Application of Jared Samples to rezone property from C-1 (Local Commercial) zoning district to MR-2 (Medium Density Residential-2) zoning district to allow for residential development, at 5561-5567 Memorial Drive.

PETITION NO: N3-2026-1100 Z-26-1248190

STAFF ANALYSIS

CASE NO.:	Z-26-1248190	File ID #: 2026-1101
Address:	5561 Memorial Drive, Stone Mountain, GA 30083	Commission Districts: 4 and 6
Parcel ID(s):	18 070 03 008	
Request:	Rezone property from C-1 (Local Commercial) zoning district to MR-2 (Medium Density Residential-2) zoning district to allow for a residential development.	
Property Owner(s):	Chaz Lazarian/Insignaia, LLC.	
Applicant/Agent:	Jared Samples	
Acreage:	13.1	
Existing Land Use:	CRC (Commercial Redevelopment Corridor)	
Surrounding Properties:	North: CRC, SUB South: CRC, SUB (Suburban), East: CRC, SUB, Pine Lake City Limits West: COS (Conservation)	
Adjacent Zoning:	North: C-1 South: MR-1 (Medium Density Residential-1) East: C-1 West: C-1	
Comprehensive Plan:	Consistent X	Inconsistent

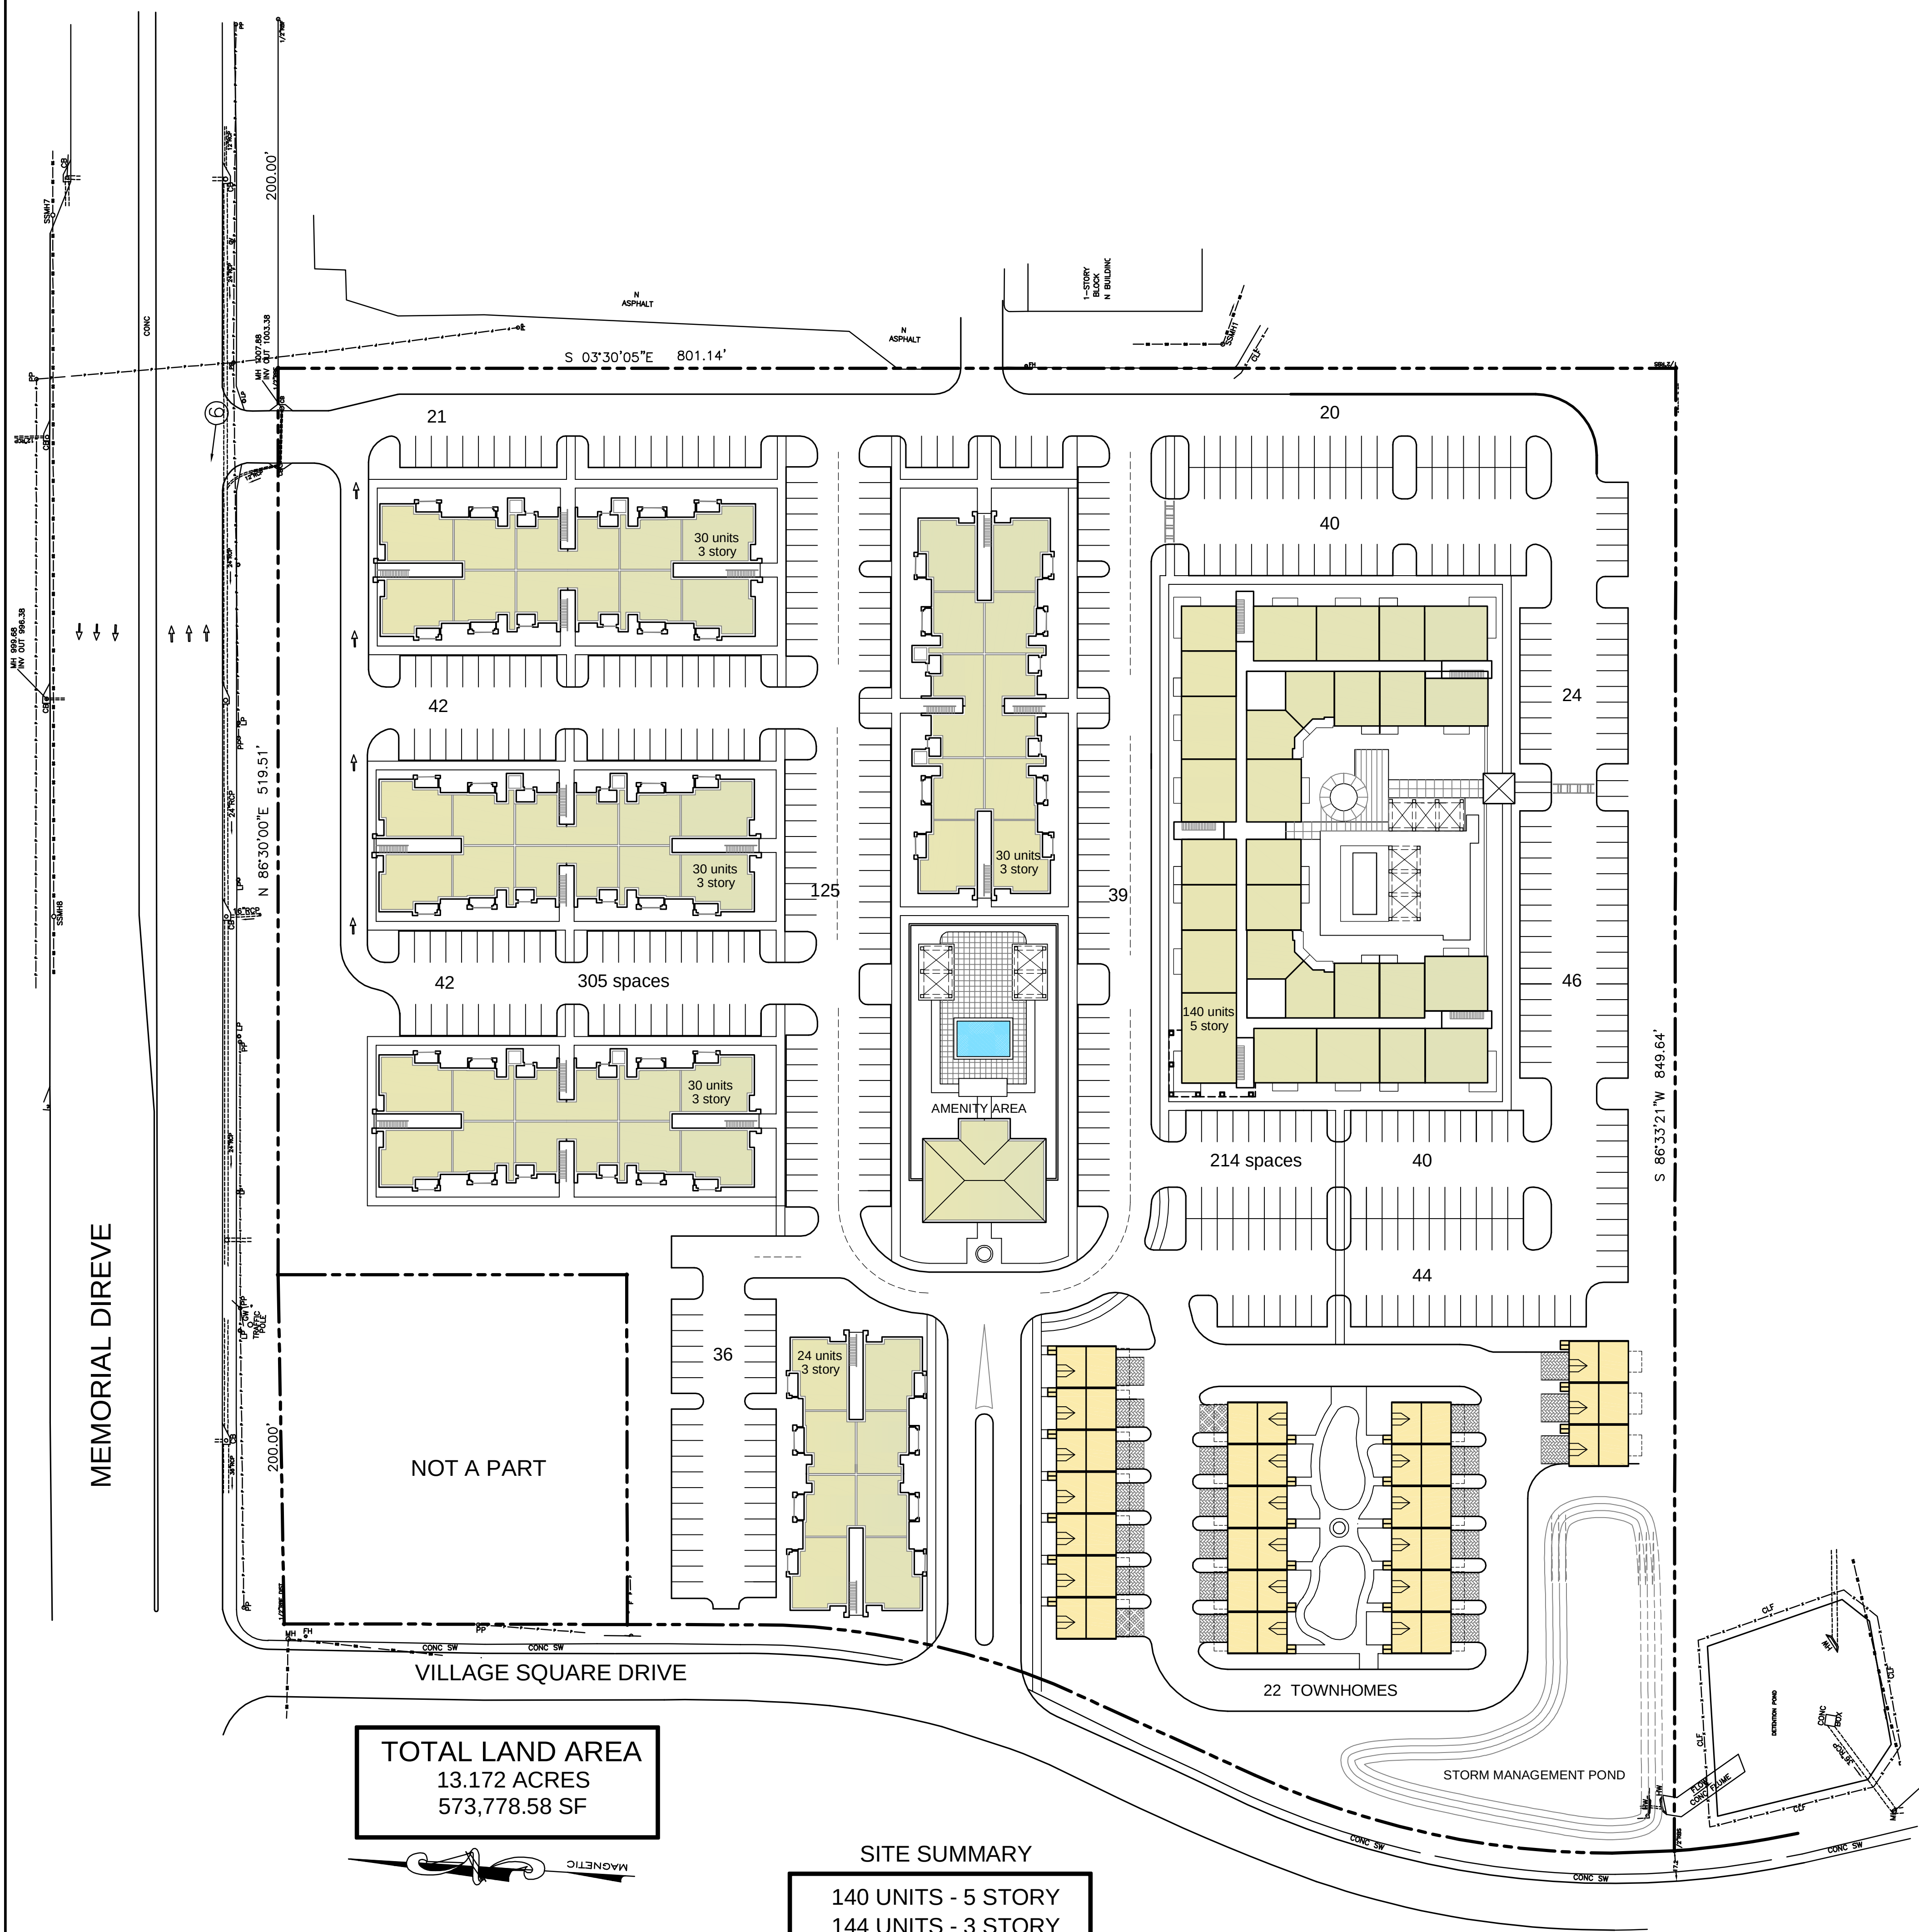
MR-2 zoning is a permitted district within the NC Character Area. However, the current concept proposes an entirely residential development of 306 units, including three- and five-story multifamily buildings and 22 townhomes. The proposed density is consistent with MR-2 but does not substantially modify the overall site organization or incorporate several elements of the NC vision identified in the SAP. Additionally, there are density inconsistencies with the site design proposal. The site design outlines 5 story building(s), whereas Section 2.14.6 (Building *Heights*) only allows up to 4 story buildings (with density bonus) unless an accessory non-residential use is proposed in an Mr-2 zoning district.

Revisions are necessary to address the scale and transition of development in relation to adjacent properties. The site is subject to a fifty-foot (50-foot) transitional buffer along the eastern and southern property lines pursuant to Section 5.4.5 (*Transitional Buffers*), which would provide separation between the proposed multifamily development and adjoining properties.

The Land Development Analysis (Interdepartmental Comments) states existing high impervious coverage creates concern of run off and due to site design, if the proposed stormwater management system will fit where proposed. The proposed site design continues to include a substantial amount of surface parking and other impervious areas. As the site plan is further refined, there may be opportunities to reconsider the amount and distribution of impervious surfaces, incorporate additional landscaped or pervious areas, and ensure adequate space for a stormwater management system that meets applicable requirements.

The revised site plan (8/11/26) does not demonstrate compliance with Section 5.4.5 (*Transitional Buffers*) or Section 2.14.6 (*Building Heights*) of the MR-2 zoning district. Additionally, several applicable MR-2 development requirements, including open space and streetscape requirements, are not sufficiently identified or demonstrated on the conceptual site plan. Given the approximately 13-acre size of the property, its prominent location along Memorial Drive, and its specific identification as a redevelopment opportunity in the Memorial Drive Corridor SAP, Staff finds that additional consideration of the proposed site organization, mix of uses, and overall Neighborhood Center (NC) character is warranted.
